Figure 0-3a— DTE System entity relationship diagram

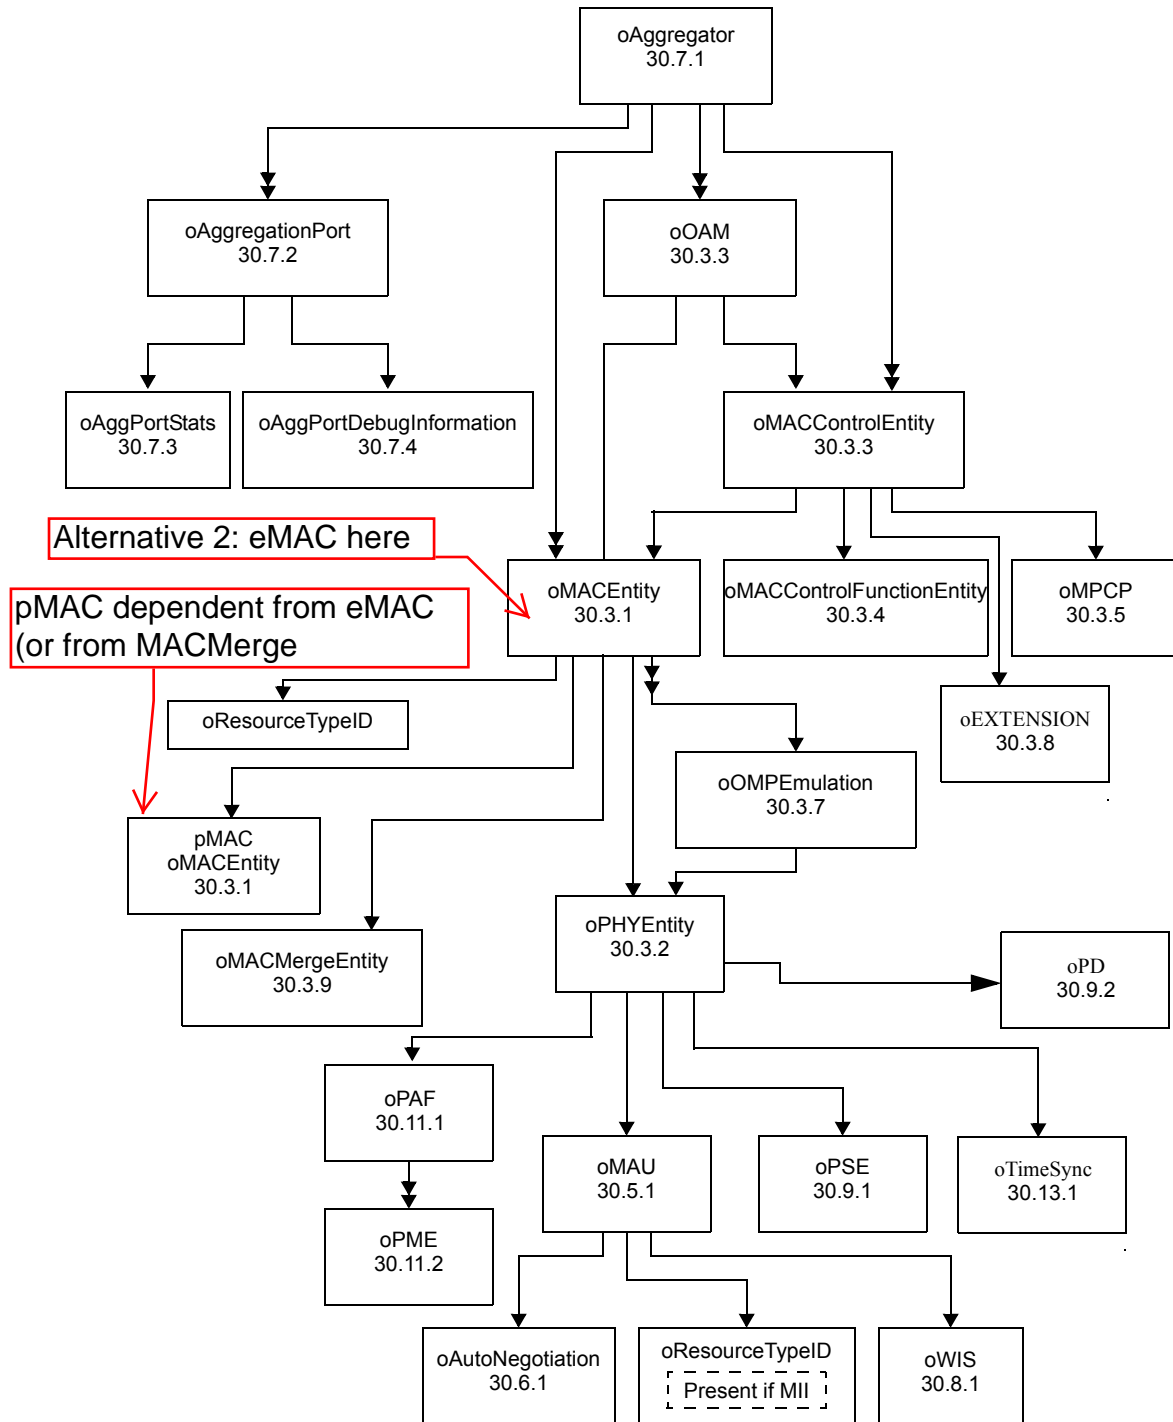
This avoids the need for a 2 to 1 relationship. Is it allowable for an object type to appear in two positions in the diagram?

Alternative 2: eMAC here

pMAC dependent from eMAC (or from MACMerge)
